PRELIMINARY SAFETY EVALUATION REPORT

TRANSNUCLEAR, INC.

STANDARDIZED NUHOMS® HORIZONTAL MODULAR STORAGE

AMENDMENT NO. 11

Figure 1.3 NUHOMS® OS197L TC System Decontamination Area Shielding

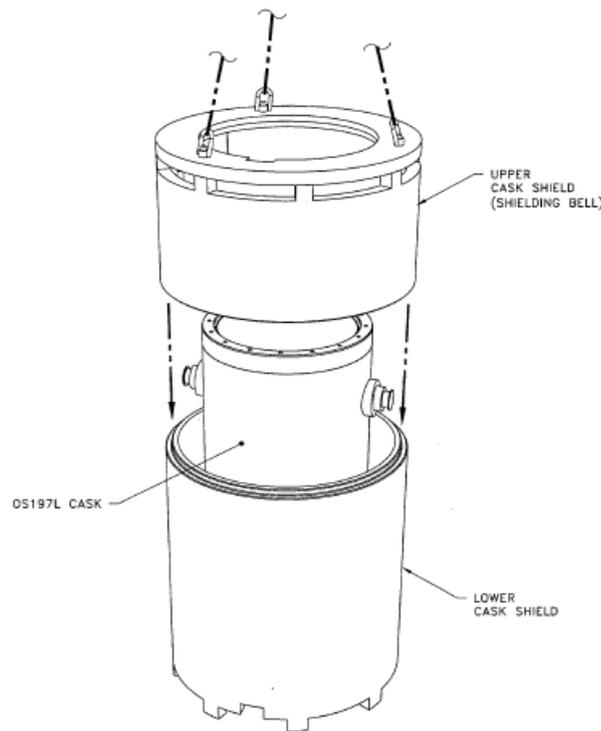
An evaluation was performed by the applicant to confirm that the radial gap between the OS197L TC and the inner diameter of the decontamination shield is sufficiently large, and that the top and bottom cut-out openings are of sufficient size as to not adversely affect the thermal performance of the OS197L TC. The decontamination area shielding is illustrated in SAR Figure W.1-2, and reproduced in Figure 1.3.

The applicant's evaluation is based on analysis of the free convection turbulent boundary layer development along the outer OS197L TC surface during vacuum drying and helium backfilling operations. The applicant states that the results of the evaluation confirm that the DSC shell-decontamination shield gap and the area of the inlet and outlet openings are adequate and, thus, the decontamination area shield does not adversely impact the cask boundary conditions assumed in the thermal analysis. No details of the analysis conducted by the applicant were provided in the SAR; however, in response to staff RAIs the applicant provided additional details for staff review.

Figure 5.1. FLUENT Model of NUHOMS® OS197L TC System with Supplemental Shielding

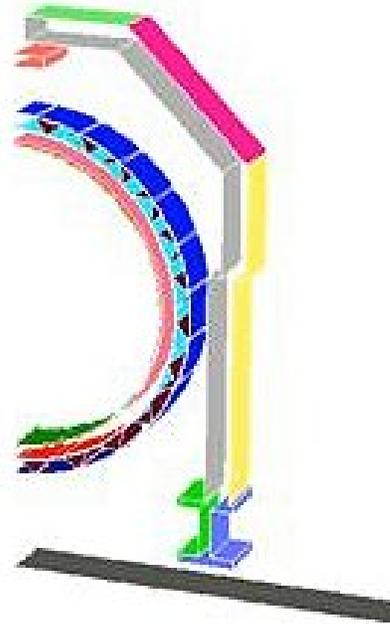
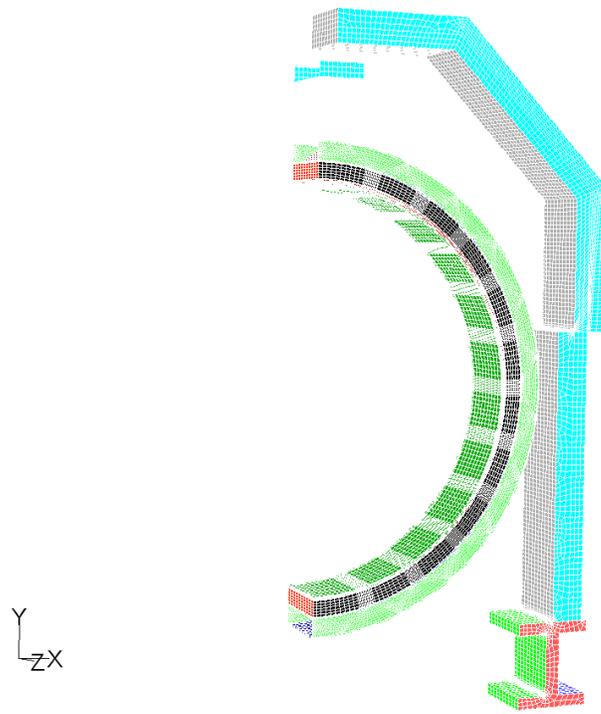
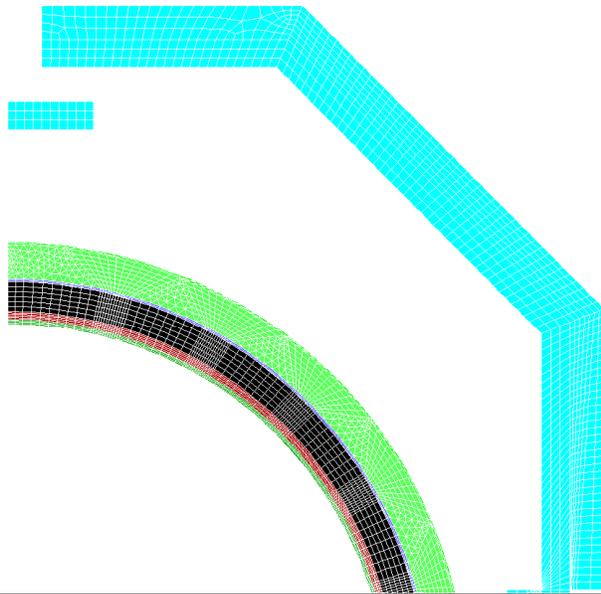
The OS197L transfer cask consists of a 2.68-inch thick steel cask body and a removable 3.5-inch thick liquid neutron shield assembly. The total water thickness of the neutron shield is 3 inches and the inner and outer stainless steel shells of the tank are 0.25 inches thick. The supplemental shielding consists of 3 sections. The lower section is a series of plates attached to the sides and ends of a typical transfer skid structure to provide the required shielding. Dual upper sections fit like clamshells over the cask and skid after the cask is placed on the transfer skid. The support legs on the skid provide an approximately 6.75-inch high clearance under the I-beams of the skid. Ambient air enters the enclosure through this clearance, flows around the

transfer cask, and exits via a 6-inch wide slot at the top, which extends 184 inches along the axial length of the supplemental shielding. (See Figures 5.1 and 5.2)

The staff's CFD analysis was performed for ambient conditions of 100°F and 24 kW of total decay heat, based on the decay heat evaluated by the applicant in earlier revisions of their SAR. The applicant later reduced the allowable decay heat load in the OS 197L TC to 13kW. A three-dimensional (3-D) FLUENT CFD model was prepared to represent a 12-inch section of the cask and the transfer skid. The representative transfer cask includes the DSC outer shell, the TC cask rails, the TC cask structural shell, and the liquid water neutron shield. Within the TC, the DSC sits on top of two cask rails, which are located 18.5° from vertical downward below the DSC. The thickness of the cask rails is assumed to be 0.12 inches. The air gap between the DSC shell and the transfer cask structural shell at the bottom closes from 0.405 inches to 0.105 inches. This air gap is also included in the analysis. A uniform 0.01-inch air gap between the cask structural shell and the neutron shield inner skin is modeled as well. The heat load of the fuel assemblies is applied as a uniform heat flux over the inner surface of the DSC shell. All material properties, including liquid water, are obtained from the applicant's SAR.

Three modes of heat transfer are included in the analysis including conduction, natural convection, and radiation. Radiation heat transfer is based on the Discrete Ordinates (DO) method. The staff performed the CFD analysis for normal conditions of transfer and obtained temperatures and a temperature distribution which are generally consistent with the trends found in the applicant's results. Therefore, based on the CFD analysis, the staff concludes that the applicant's approach to represent the heat transfer through the OS197L transfer cask is acceptable.

Figure 5-3 Peak Component Temperatures for 32PT DSC in OS197L TC: Off-Normal Conditions of Transfer (117°F ambient)

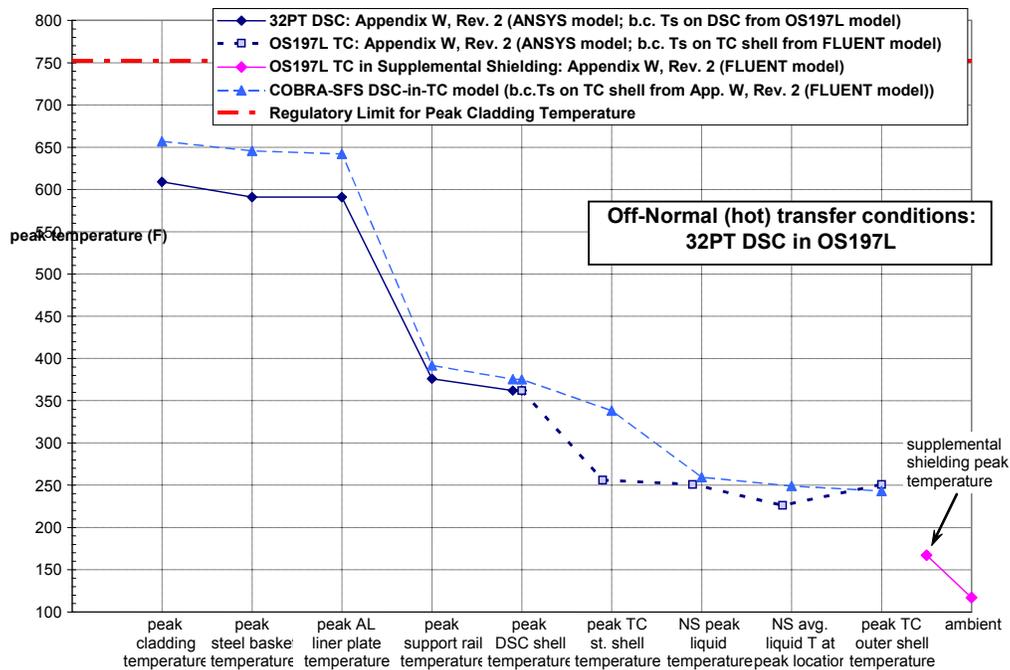
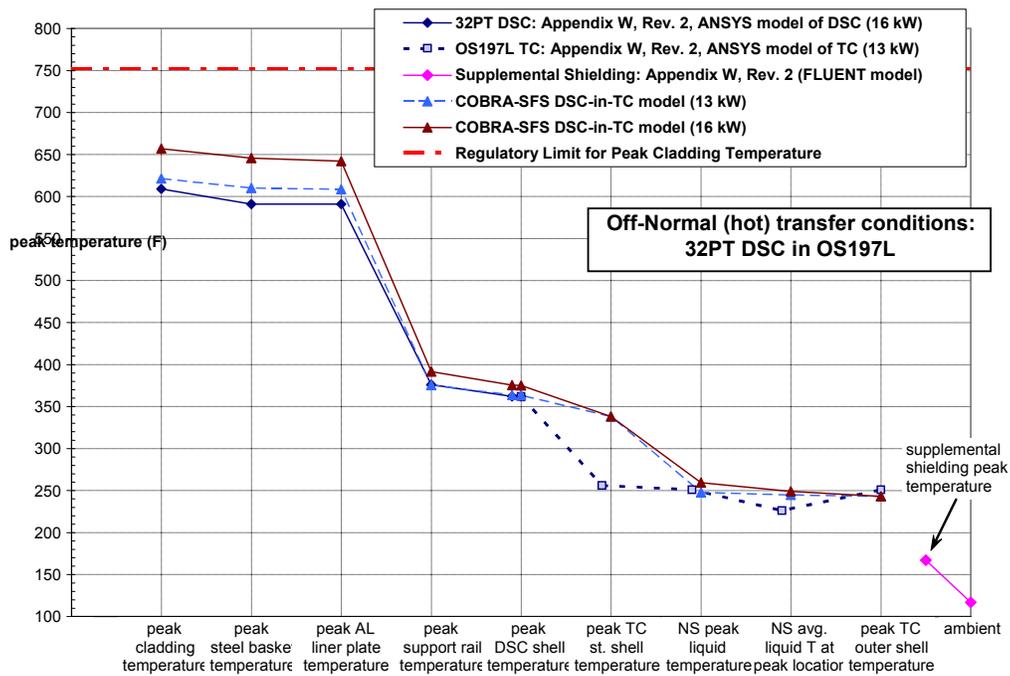
The temperature profile comparisons in Figures 5-3 and 5-4 show very good agreement in the results obtained for the OS197L transfer cask, and the peak DSC shell temperatures differ by

only about 16°F. The peak temperatures predicted for the aluminum support rails differ by approximately the same amount, with the confirmatory calculation results the more conservative of the two. (This is also in contrast to the results for the DSC model shown in Section 4.5.4, in which the SAR model results are more conservative than the confirmatory calculations.) Figure 5-5 shows this conclusively, with confirmatory calculation results with a COBRA-SFS model of the DSC only compared to Appendix W results for the detailed DSC model. In this comparison, both calculations use the same boundary temperatures on the DSC outer shell.

The plots in Figures 5-3, 5-4, and 5-5 show that the difference between the SAR Appendix W results and the confirmatory calculations are due two main causes. These are (1) differences in the detailed DSC model, in which the SAR model predicts a higher rate of heat transfer through the basket, and (2) decoupling of the DSC and TC heat transfer solution in the two-step approach used in the SAR methodology. The two effects are additive, in that both result in lower predicted peak component temperatures within the DSC. The differences in the detailed DSC model result in a higher predicted rate of heat removal from the basket, and the decoupling of the DSC and TC results in lower boundary temperatures on the DSC shell.

As indicated in Figure 5.3 above, the non-conservative results obtained with the SAR model compared to the confirmatory calculations can be further illustrated by comparison with results reported in Appendix M, for the 32PT within the original (heavier) OS197. Figure 5-6 shows the results for the 32PT using the DSC shell temperatures reported in Appendix M. As with the comparison for Appendix W (shown in Figure 5-5), the confirmatory calculation results are more conservative than those obtained with the ANSYS model documented in Appendix M. The peak cladding temperature predicted in the confirmatory calculations is approximately 24°F higher than the value obtained with the ANSYS model and reported in the SAR. However, for the 32PT DSC within the OS197, which does not require supplemental shielding, the peak cladding temperature obtained in the confirmatory calculations is 13°F below the temperature limit, and therefore the results obtained with the methodology documented in Appendix M were deemed acceptable.

For application to the analysis of the 32PT within the OS197L as presented in Appendix W, however, the non-conservatism of the methodology from Appendix M with respect to the confirmatory calculations is unacceptable, because the peak cladding temperatures are predicted to be much closer to the limit. The results obtained in the confirmatory calculations

predict peak cladding temperatures that are above the regulatory limit for normal and off-normal

Figure 5-5 Peak Component Temperatures for 32PT DSC with DSC shell boundary temperatures from OS197L TC model in Appendix W: Off-Normal Conditions (117°F ambient)

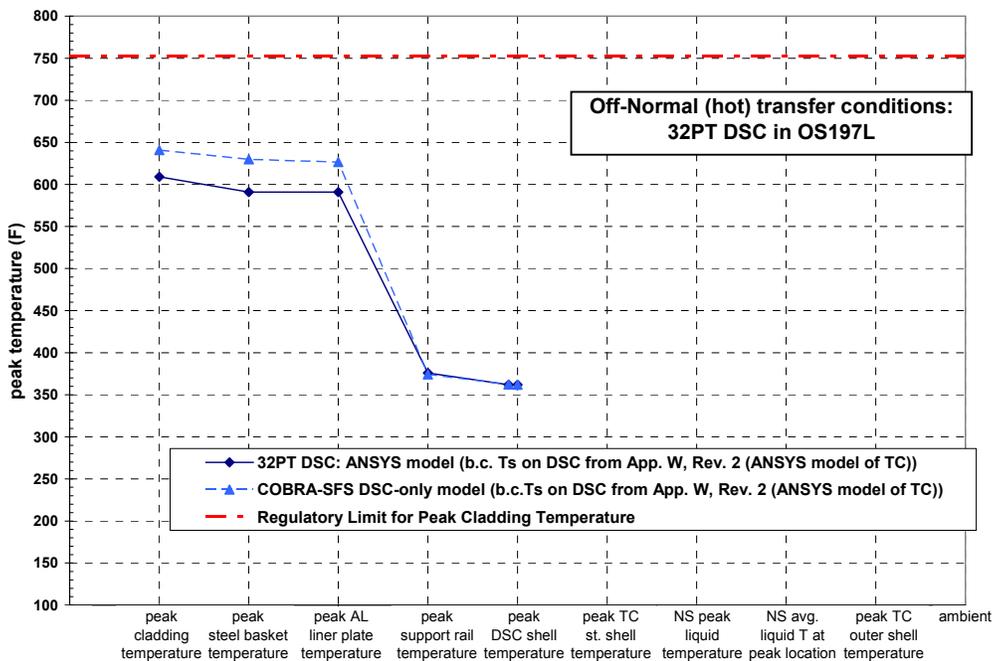
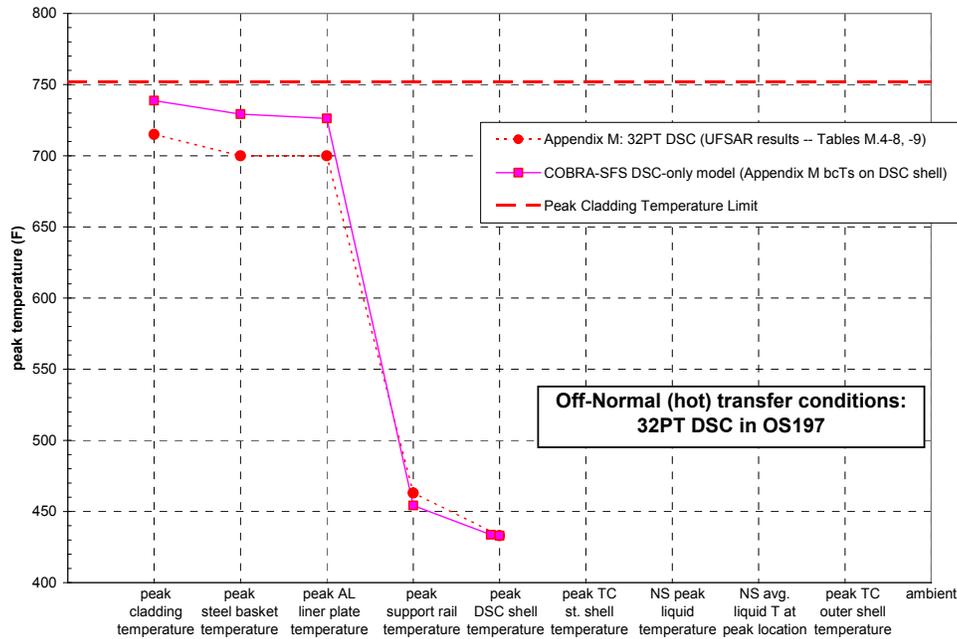
conditions of transport for a heat load of 24 kW. These results were obtained using the boundary temperatures calculated by the applicant, using their FLUENT model of the TC within the supplemental shielding.

Figure 5-7 Peak Component Temperatures for 32PT DSC within OS197 TC, with and without supplemental shielding: Off-Normal Conditions (117°F ambient)

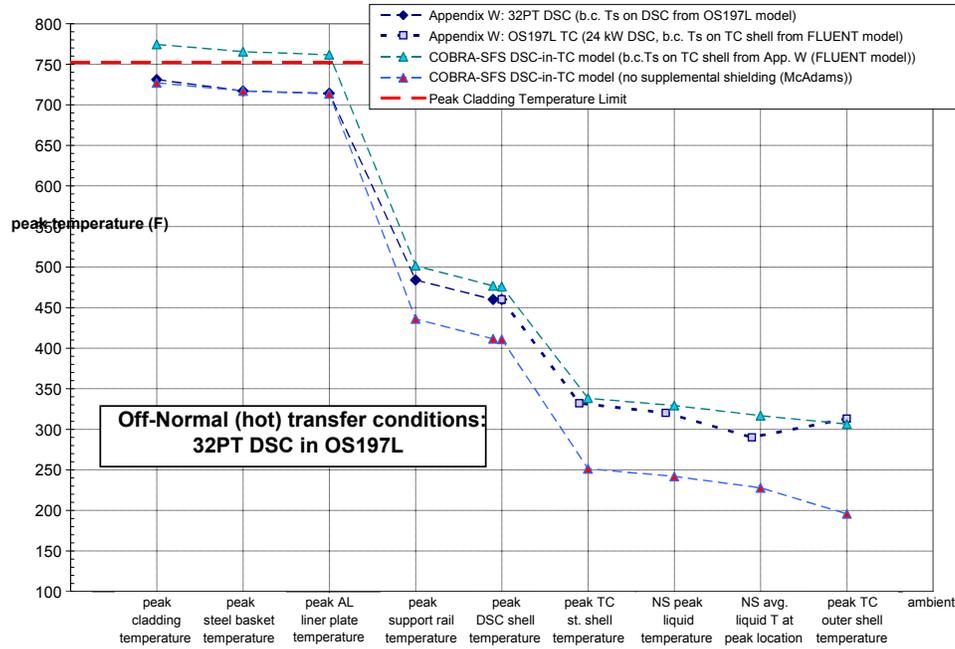
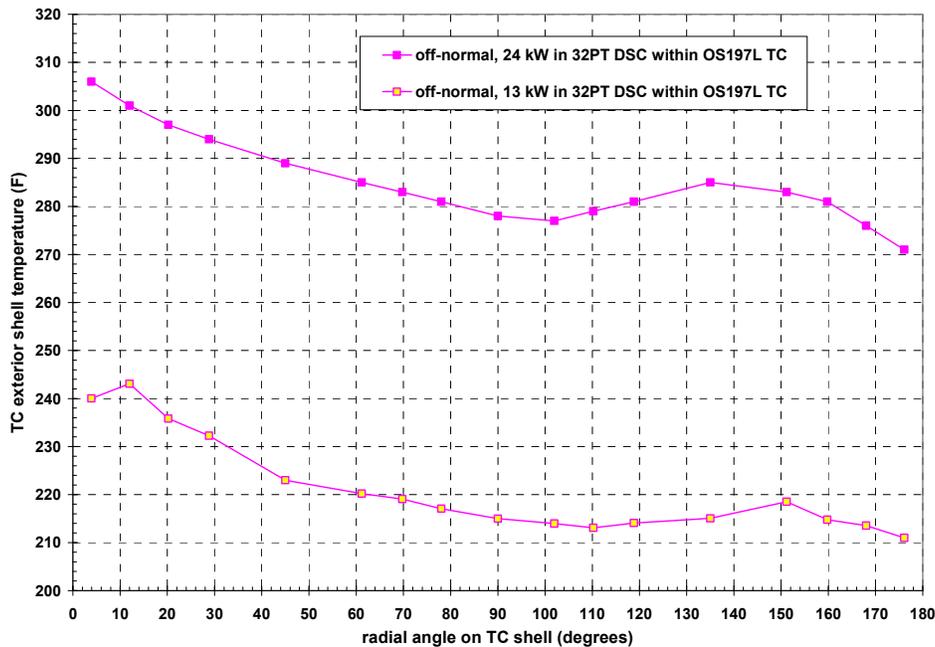
The results obtained for this case are compared to the SAR Appendix W results in Figure 5-7. The confirmatory calculations indicate that without the supplemental shielding, the peak temperature on the OS197L external surface would be more than 100°F lower than the value predicted in the SAR Appendix W with the FLUENT model. As a result, the peak cladding temperature in the confirmatory calculation is only about 727°F, which is 4°F below the value predicted with the SAR methodology *with* the supplemental shielding in place. This further illustrates the non-conservatism of the detailed DSC model in the SAR.

During the course of the staff's review, the applicant chose to revise the maximum decay heat loading for the 32PT DSC downward from 24 kW to 13 kW. Additional calculations were submitted showing the results obtained with the FLUENT model of the OS197L within the

supplemental shielding, with a 13 kW decay heat load represented as a uniform surface heat flux on the TC outer shell. Figure 5-8 shows the effect on the predicted TC surface temperatures, in which the reduced heat load results in the reduction of the TC surface temperature by approximately 60 °F (33.3°C).
